From: [Geri Gaeta](#)
To: [Planning - Info - Shr](#)
Subject: Public Comments for 5/06 TAC Meeting: 361 Hanover
Date: Monday, May 5, 2025 2:50:56 PM

Regarding 361 Hanover Steam Factory LLC Design Review

Comments Related to Revisions to the Proposed Mixed-Use Development - **361 Hanover St**

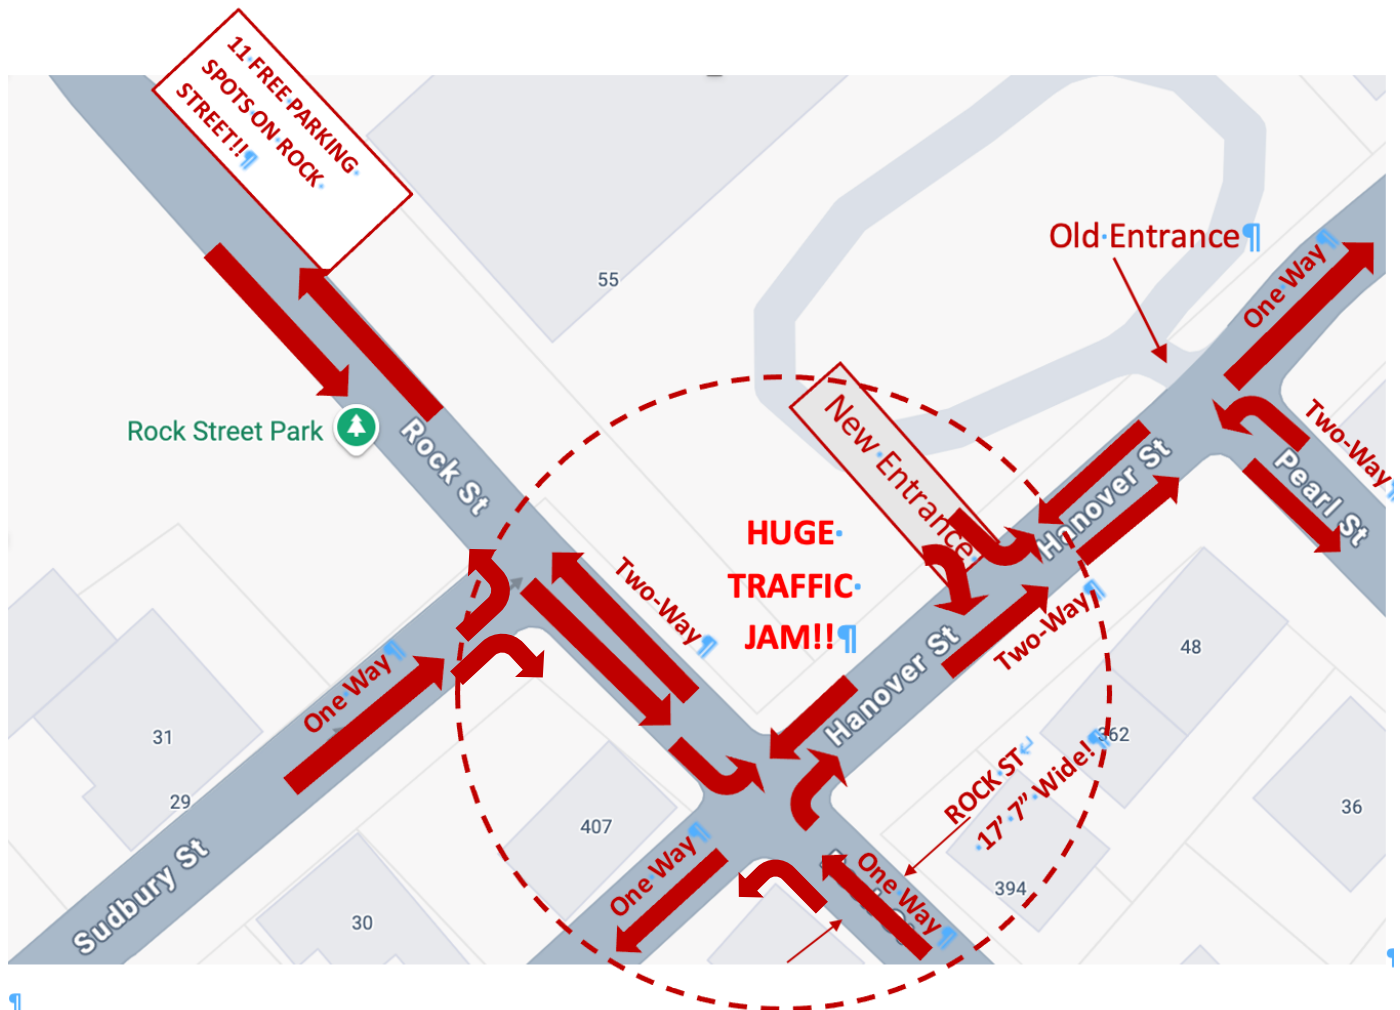
I'm generally in favor of the 361 Hanover St project as current presented with one caveat: Traffic increase impact on Hanover St. To elevate this issue I would request the city agree to move the access gate at the bottom of Rock St to southeast side of Sudbury St at the intersection of Rock St. That the developer create the drive to access the property from Rock St instead of Hanover St.

I'm thinking moving the gate so that traffic from Sudbury and the development both turn toward North Mill Pond on Rock St would remove traffic from the development and McDonough St from Hanover St. All would exit the neighborhood on Foundry PL.

NEIGHBORHOOD-REVISED DESIGN TO ADDRESS TRAFFIC ISSUES

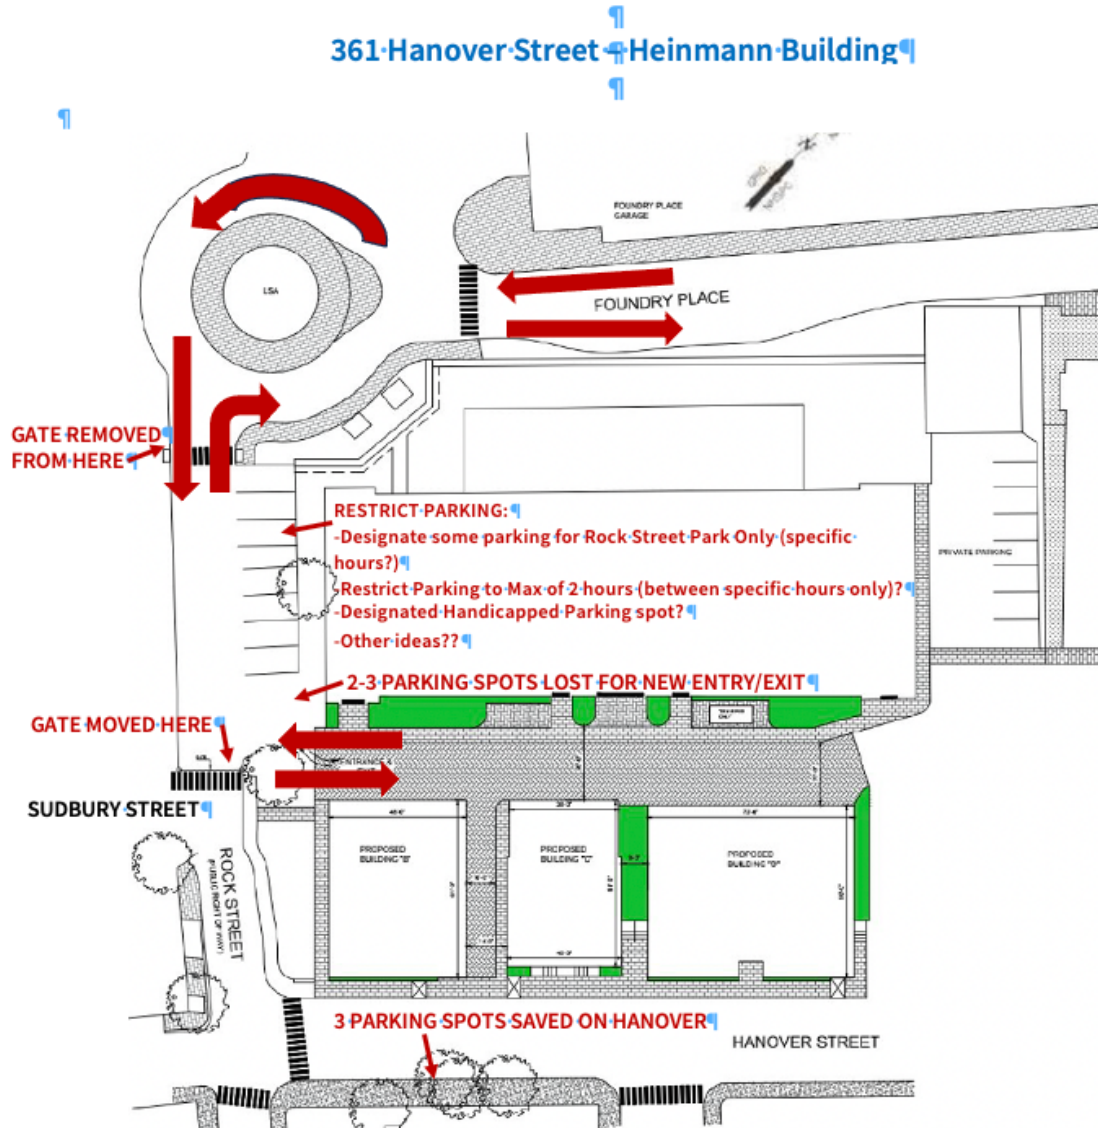
- **The Proposed Location for the Entrance/Exit on Hanover Street will cause a huge traffic jam at the intersection of Hanover and Rock Streets.** This area is too congested already and the streets are narrow. Additionally, there are currently 3 parking spots on Hanover Street opposite the new Entrance/Exit – there won't be enough room for vehicles (especially the larger delivery trucks) to safely exit and enter the project without these 3 spots being removed. Parking is already a huge challenge as it is and losing these 3 spots will only make the issue worse:

- A Better Solution For the Entrance/Exit for the project -- A New Entrance from Rock Street:** It is recommended by the majority of residents in our neighborhood that the Entrance/Exit to this project be from Rock Street so traffic for this development will flow on Foundry Place, on a road intended for commercial amounts of traffic, and enter the project from Rock Street, instead of flooding our neighborhood which is already congested with vehicles, avoiding a huge negative impact on our neighborhood. This would require sliding the current Gate located at the rotary up to Sudbury Street:
